Application for Works Approval

Works Approval Number	W6919/2024/1
Applicant	Covalent Lithium Pty Ltd
ACN	70 623 090 139
File number	DER2024/000078
Premises	Earl Grey Lithium Project Marvel Loch-Forrestania Road MOUNT HOLLAND Legal description Mining Tenement M77/1080 As defined by the Premises map in Schedule 1 and the coordinates in Schedule 2 of the issued Works Approval
Date of report	22 August 2024 (FINAL)
Proposed Decision	Works approval granted

Figure 2: Water storage tank option and associated infrastructure

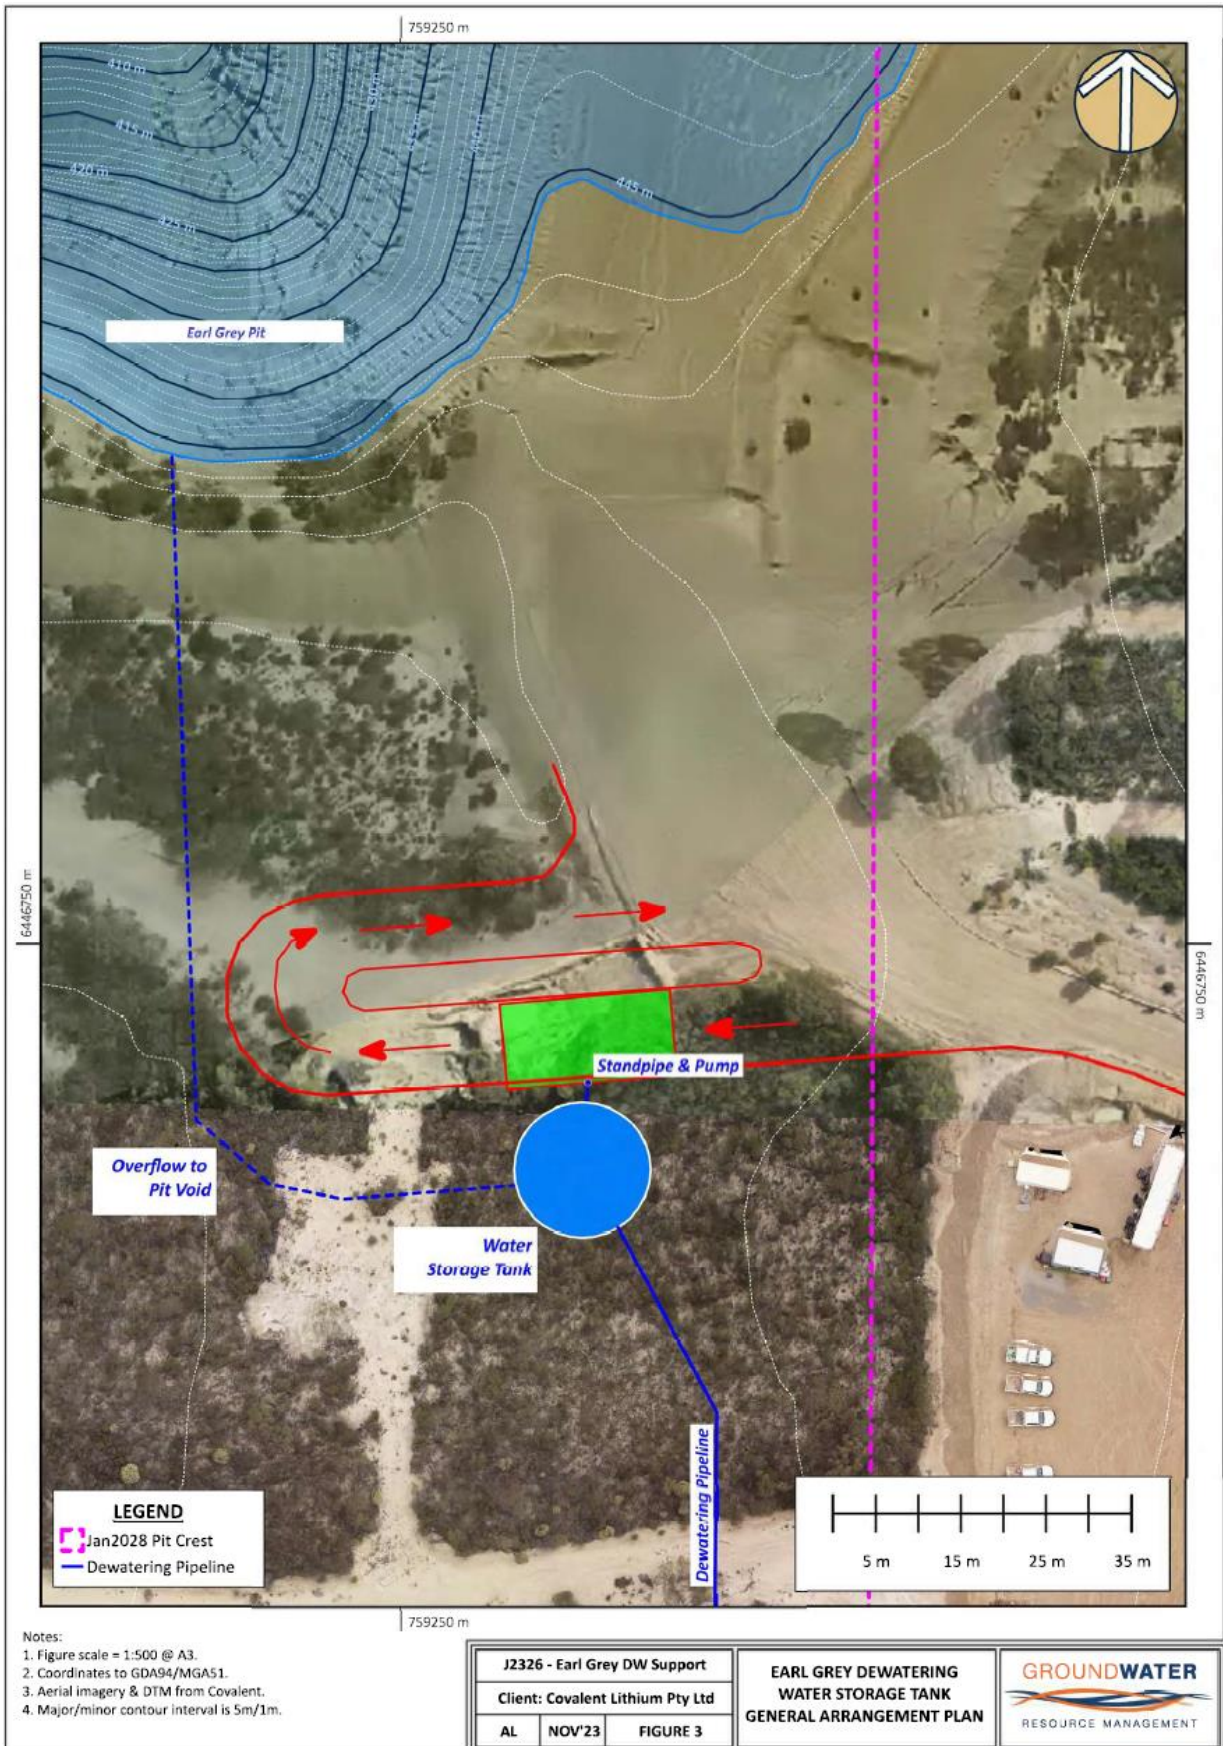
Condition 1, Table 1, Item 6	Covalent has decided that the overflow channel will be a pipe from tank overflow point, not an open channel. Suggests that similar conditions that were proposed for the other pipelines be applied to the overflow pipeline.	The Delegated Officer is satisfied with the proposed changes and has updated condition requirements to reflect.
